AMENDMENT
U.S. Appln. No. 09/782,201

AMENDMENTS TO THE DRAWINGS

REMARKS

**FIG. 1****FIG. 2**

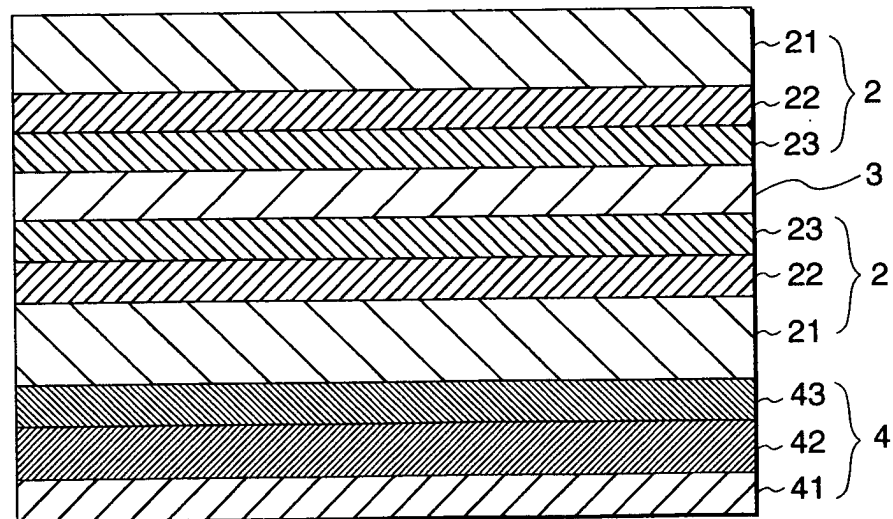
Referring to the second paragraph at page 2 of the Office Action, the examiner has objected to FIG. 2. Specifically, the examiner requests that FIG. 2 be amended to contain a legend, such as "Prior Art." According to the examiner, only that which is old is illustrated in FIG. 2.

The attached drawing sheet includes a change to FIG. 2. The sheet replaces the original sheet (sheet 1 of 1) including FIGS. 1 and 2. In FIG. 2, the caption "PRIOR ART" has been added.

In response, FIG. 2 has been amended by inserting therein the legend "Prior Art," which is supported by, for example, the description at page 4, lines 15-16, of the specification.
